WATER QUALITY MEMORANDUM

Utah Coal Regulatory Program

RE: First Quarter of 2014 Water Monitoring, Genwal Resources, Inc., Crandall Canyon Mine, C/015/0032 Task ID #4541

Crandall Mine - Untreated Mine Water - Total Iron Monthly Median

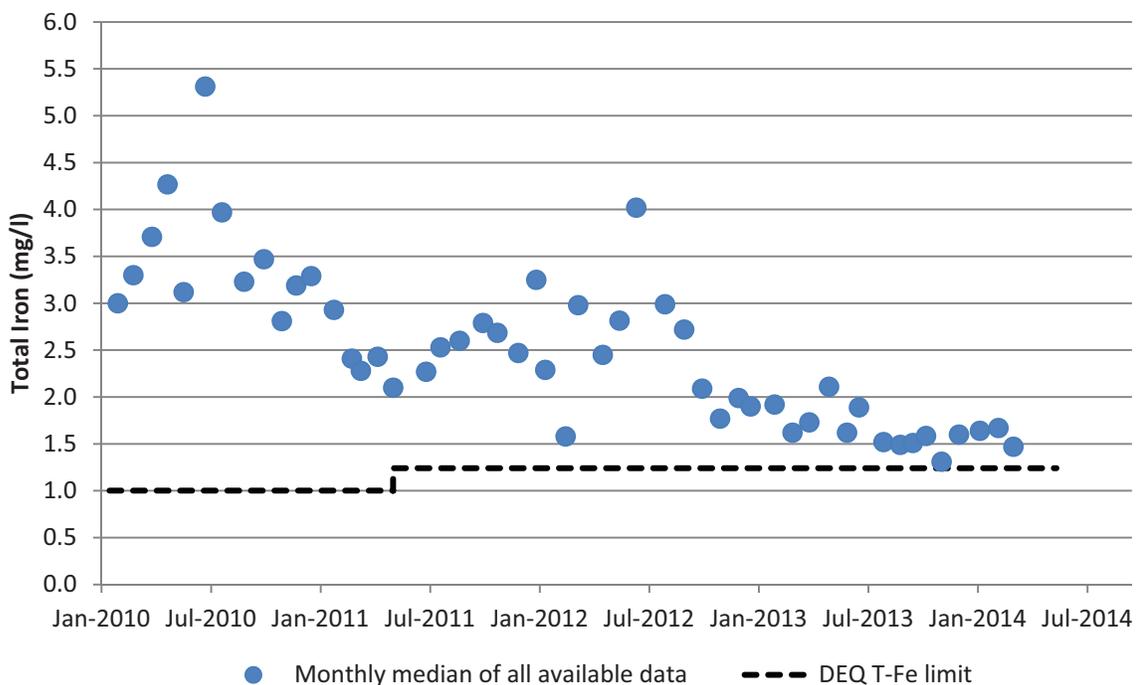
The total iron concentrations in the pre-treatment mine water remains above the 1.24 mg/L UPDES limit. Based on three sampling events the resulting concentrations for total iron were 1.74, 1.91, and 1.46 mg/L for January, February, and March, respectively. The data show that total iron concentration still remains variable but since January 2010 to December 2013 a downward trend occurred. Residual polymer testing was conducted by SGS laboratory and determined a level of residual flocculent of 0.29 mg/L, <0, and 0.13 mg/L for samples collected in January, February, and March, respectively. Below is a graph of the pretreatment total iron concentration shown as a monthly median since January 2010.
